**Request for Additional Information No. 20, Revision 0**

**7/28/2008**

**U.S. EPR Standard Design Certification**

**SRP Section: 09.05.01 - Fire Protection Program**

Figure 9.5.1-1—Fire Water Distribution System  
Sheet 12 of 13

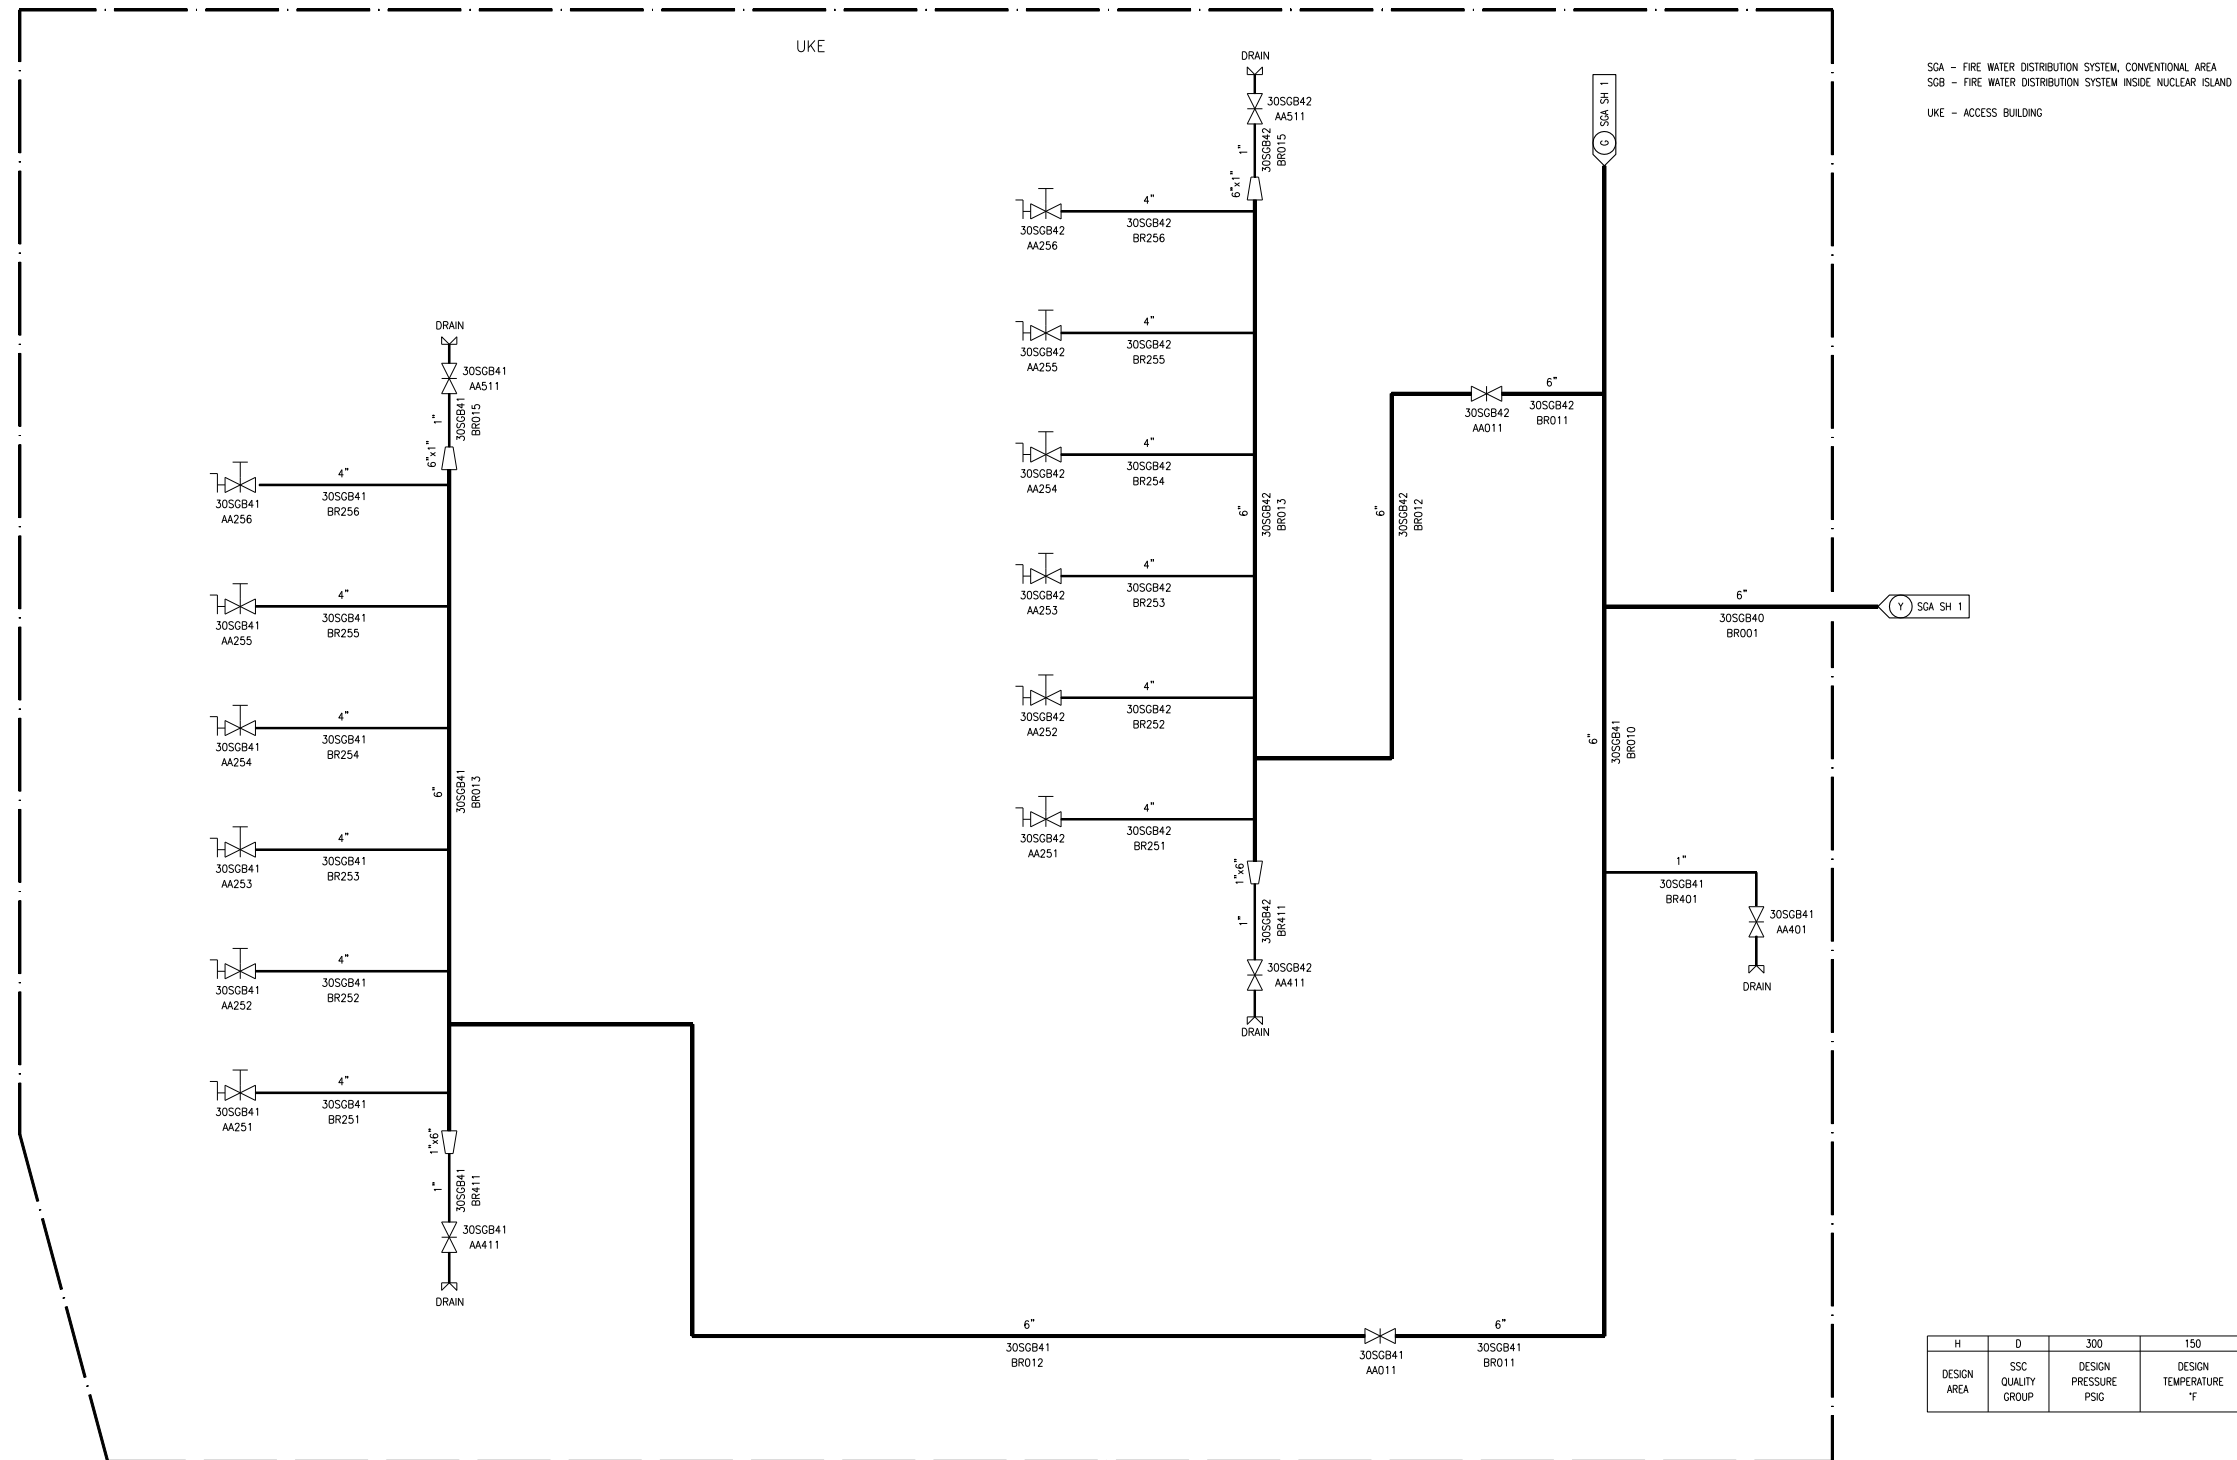
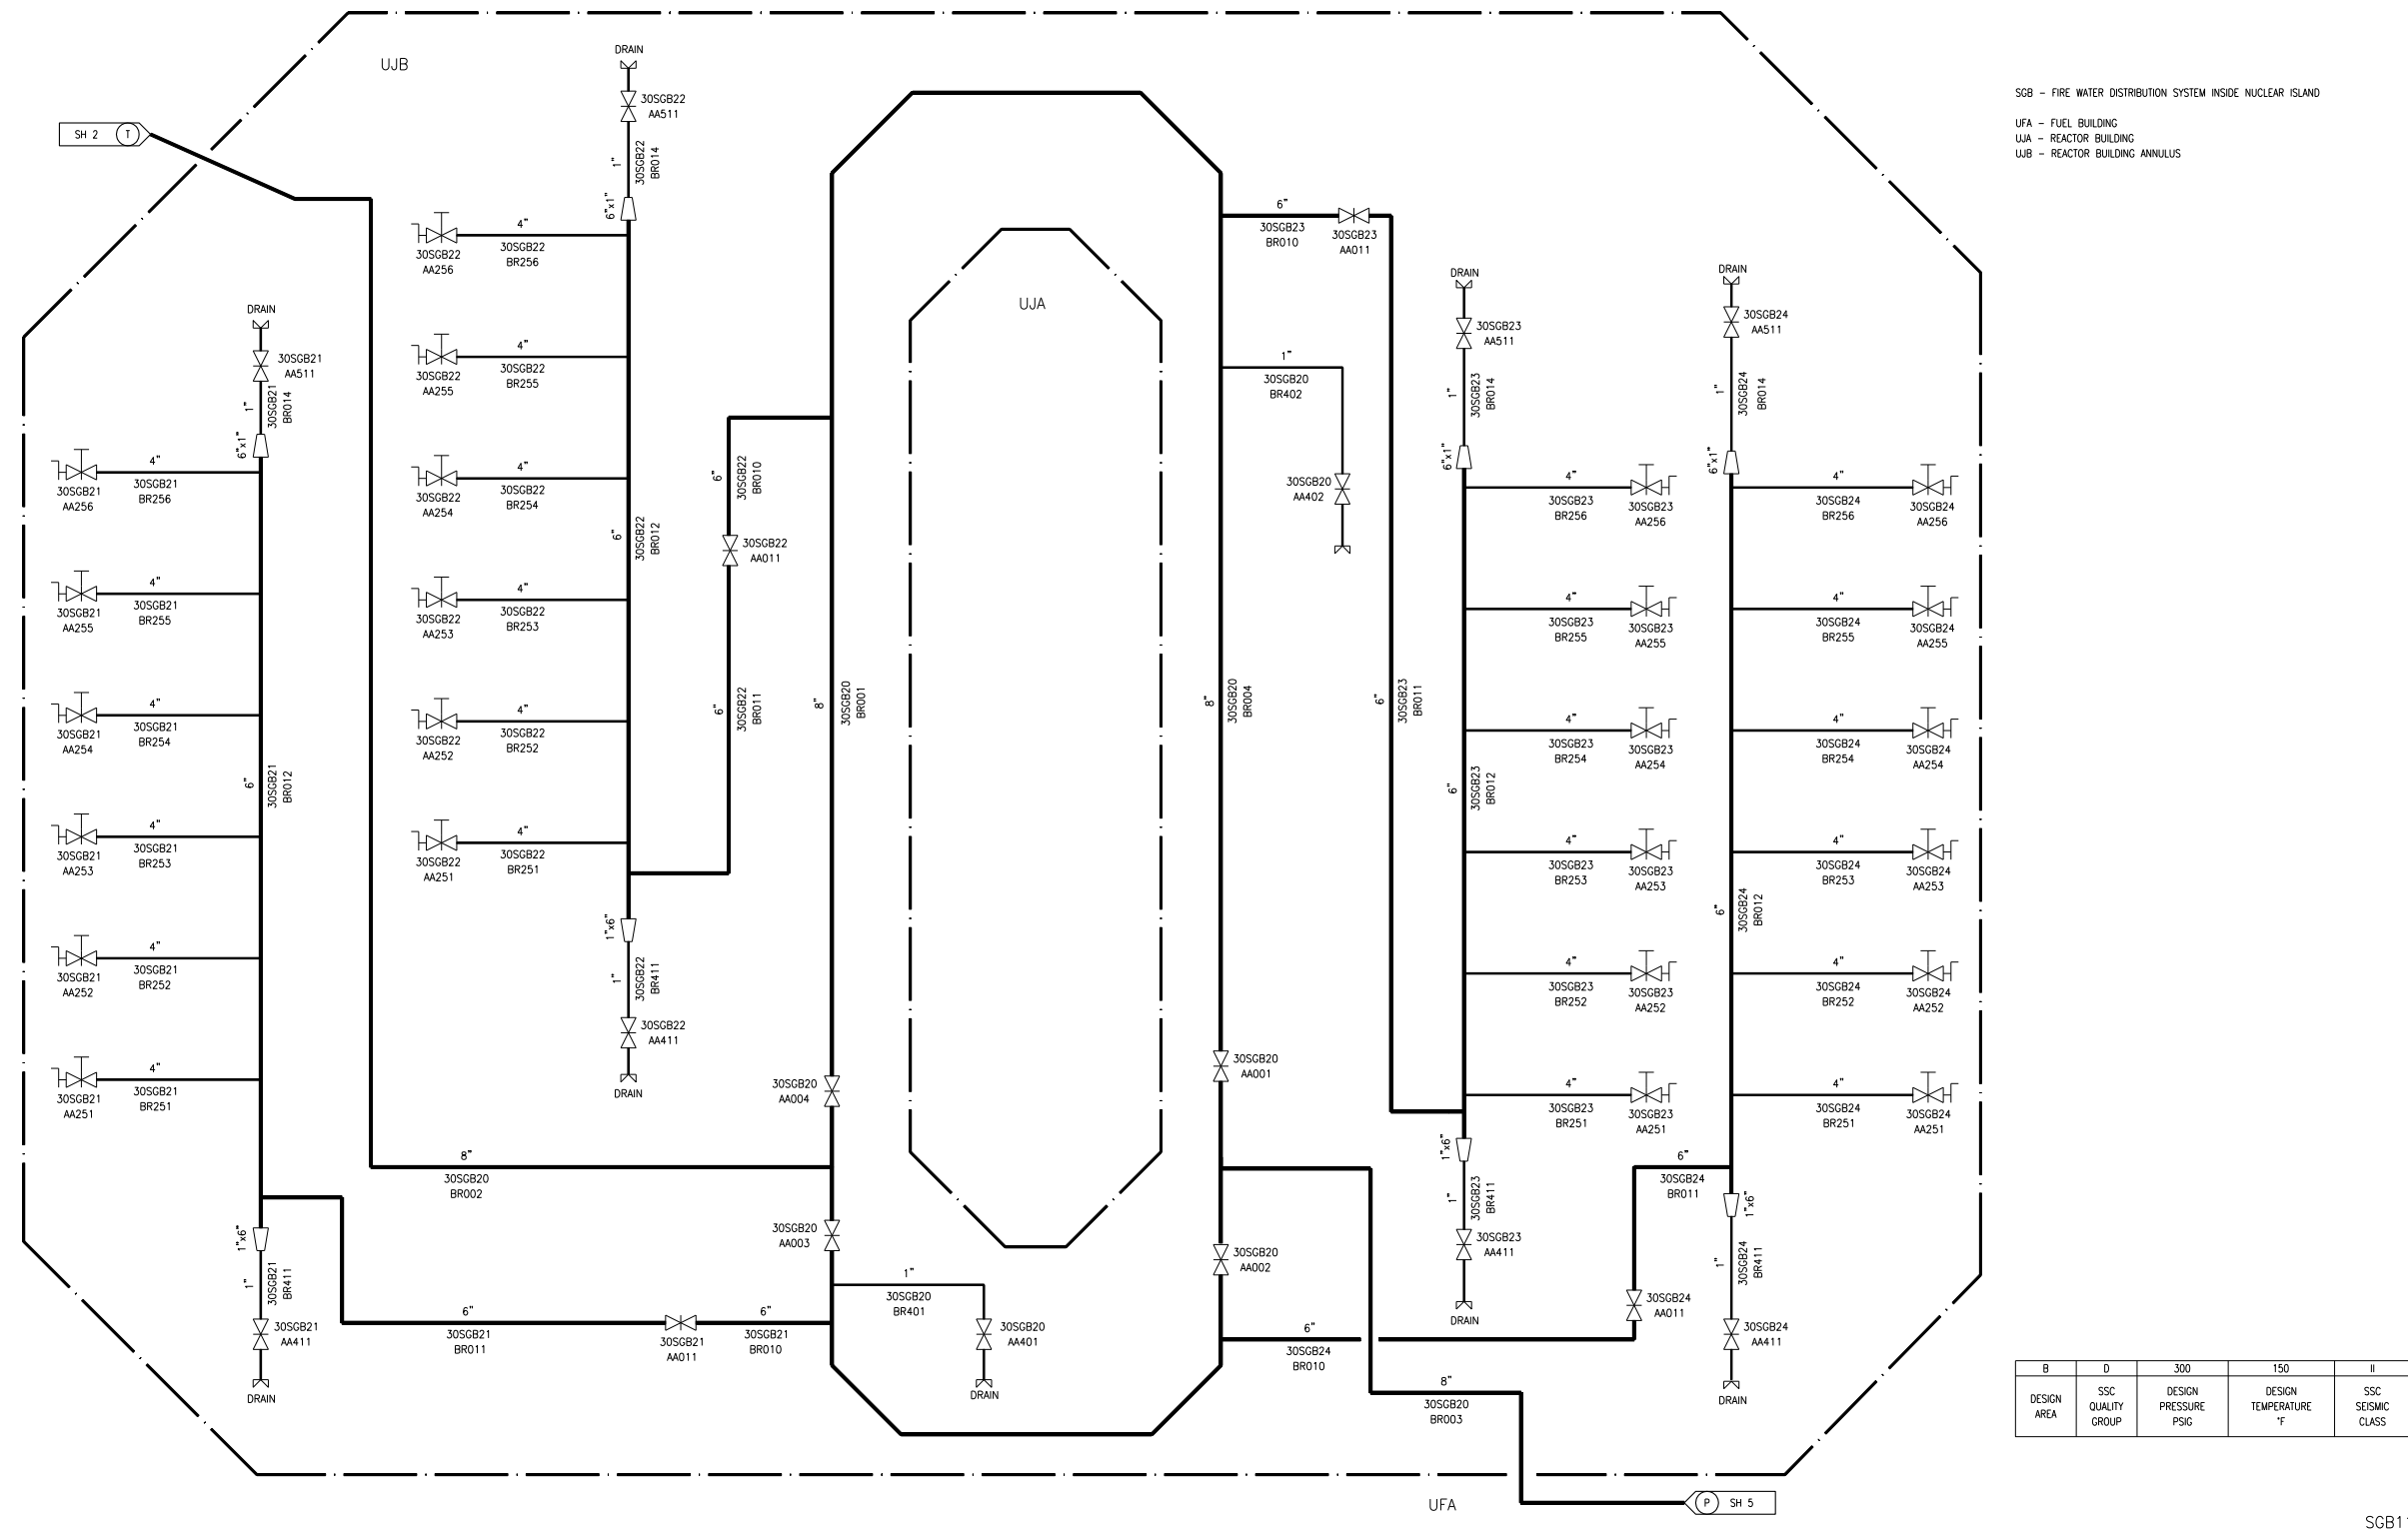
The EPR FSAR should add a COL information item to provide simplified FPS piping and instrumentation diagrams showing complete site-specific systems. Nuclear Island definition is different in Figure 9.5.1-1 then in Tier 1 Section 2.1.1. Modify FSAR accordingly. Basis: Completeness of application.

U.S. EPR FSAR Tier 2, Figure 9.5.1-1 depicts the fire water distribution system for the Nuclear Island (NI) and plant areas not considered part of the NI. However, the current title for this figure is "Fire Water Distribution System Inside Nuclear Island."

The title for U.S. EPR FSAR Tier 2, Figure 9.5.1-1 will be changed to "Fire Water Distribution System." The reference to this figure in U.S. EPR FSAR Tier 2, Section 9.5.1.2.1, under "Fire Water Supply System," will be revised to reflect the new title identified above.

U.S. EPR FSAR Tier 2, Section 9.5.1.2.1 will be revised as described in the response and indicated on the enclosed markup. U.S. EPR FSAR Tier 2, Figure 9.5.1-1 will be revised as described in the response and indicated on the enclosed markup. U.S. EPR FSAR Tier 2, Table 1.8-2 will be revised as described in the response and indicated on the enclosed markup.
